Palmdale Hybrid Power Project

Supplemental Responses from July 9, 2009 Committee Conference, including requests from the July 29, 2009 Workshop

In the Matter of:) Docket No. 08-AFC-09
)
APPLICATION FOR CERTIFICATION,) JULY 28, 2009 WORKSHOP DATA
FOR THE PALMDALE HYBRID POWER) REQUESTS – VISUAL, WATER AND
PROJECT BY THE CITY OF PALMDALE) BIOLOGICAL RESOURCES
)
)
_____)

In the Matter of:) Docket No. 08-AFC-9
)
APPLICATION FOR CERTIFICATION,) JULY 28, 2009 WORKSHOP DATA
FOR THE PALMDALE HYBRID POWER) REQUESTS – TRANSMISSION SYSTEM
PROJECT BY THE CITY OF PALMDALE) ENGINEERING
)
)
_____)

CONCEPTUAL SITE LAYOUT

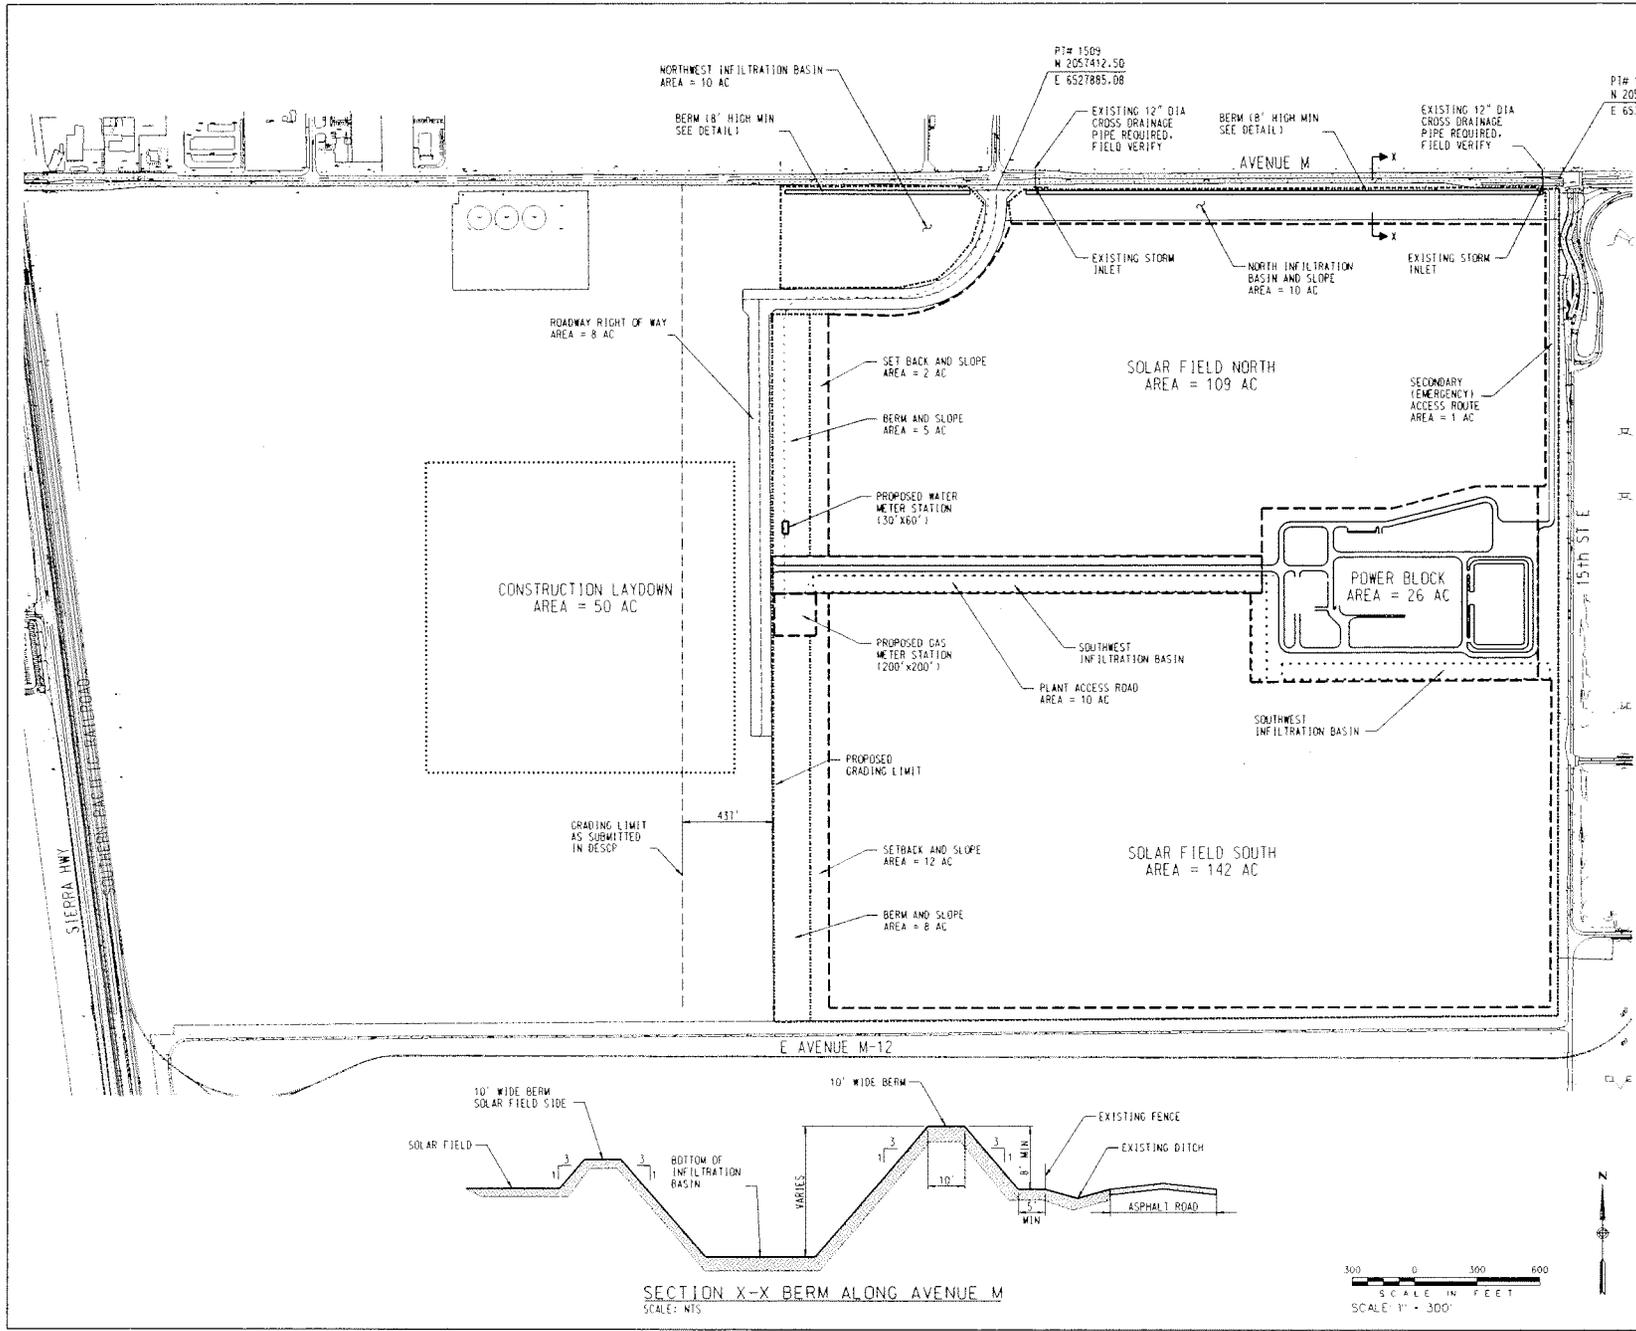
Staff requested a conceptual site layout that included more detail regarding the proposed berm to be located along East Avenue M, including the dimensions of the berm. The requested site layout, which includes a cross-section of the berm, is attached. The minimum distance between the southernmost edge of East Avenue M and the solar field will be 150 feet. Given this distance, the height of the berm (approximately 8 feet), and the height of the solar arrays (approximately 20 feet), the berm will effectively shield the solar field from the view of motorists and pedestrians on E Avenue M, as depicted in the visual simulation attached to the Applicant's Responses to Staff Status Report 4 docketed June 30, 2009.

CEC Staff requested clarification of the drainage facilities associated with the proposed berm along East Avenue M. The attached conceptual site layout includes the existing and proposed drainage facilities.

REV	DESCRIPTION	DATE
0	ABOVE BERM DETAIL	07-30-09
X	ISSUE FOR REVIEW	04-15-09

PROJECT: PHPP / SCE CDWR 230KV T-LINES
FIGURE B-2
PALMDALE, CALIFORNIA

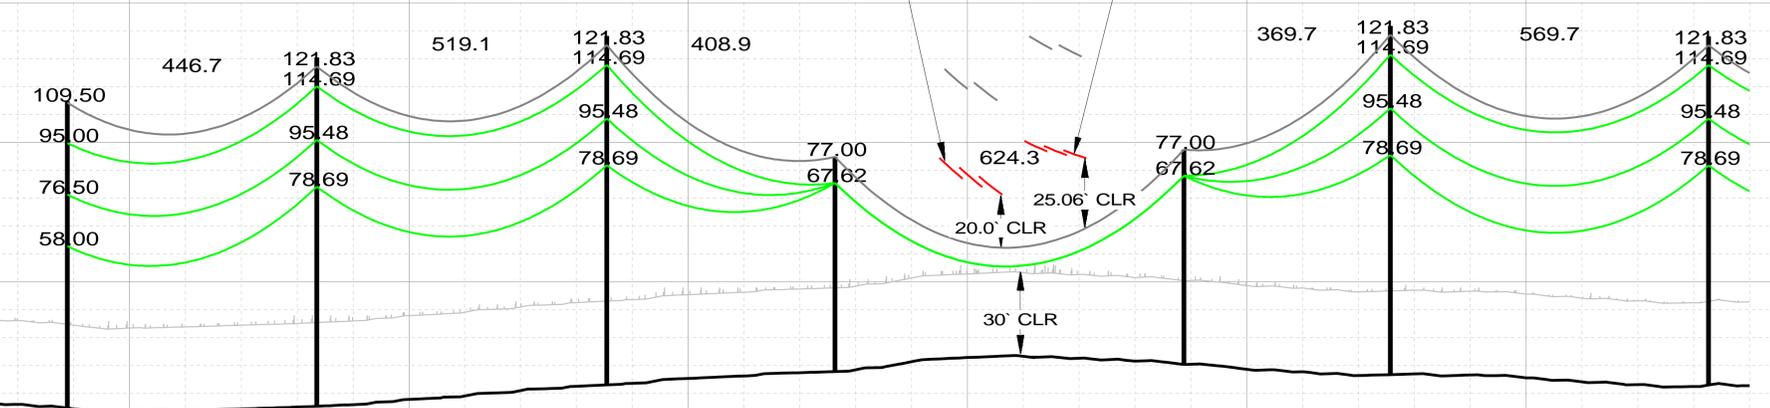
CEC Staff asked the Applicant to confirm clearance from conductor-to-ground and from conductor-to-conductor at the transmission line crossings, and to confirm that G.O. 95 Table 2 – Case 13 and Table 1 – Case 4 were used in the calculation.

The required clearance pursuant to G.O. 95 between the 500 kV and 230 kV is 19.16 feet and that distance is based on Table 2 – Case 13 of G.O. 95. The equation is 150 inches + 0.40 inches for anything over 300 kV, which in this case is an additional 200 kV. [200 x 0.40 inches = 80 inches] 150 inches + 80 inches = 230 inches or 19.16 feet. PHPP will design the line at 20 foot clearance. The detailed engineering phase will account for the maximum sag on the 500 kV line and the project will use the results from the lidar map showing the exact elevations. The 19.16 feet starts at the top conductor or static line (if there is one) of the 230 kV line and goes up to the maximum perpendicular sag point of the 500 kV conductor. The distance between them must be 19.16 feet. The distance below the top conductor or static line (if there is one) does not matter.

Attached are the two applicable G.O. 95 codes that will be used for the engineering phase of the project. Also attached are the revised crossing diagrams showing the clearance that will be used for the crossings.

19.06' CLEARANCE FROM 220KV SKYLINE TO 500KV CONDUCTOR (TOWER - ADL-RIN I).

25.06' CLEARANCE FROM 220KV SKYLINE TO 500KV CONDUCTOR (TOWER - VICTOR I).
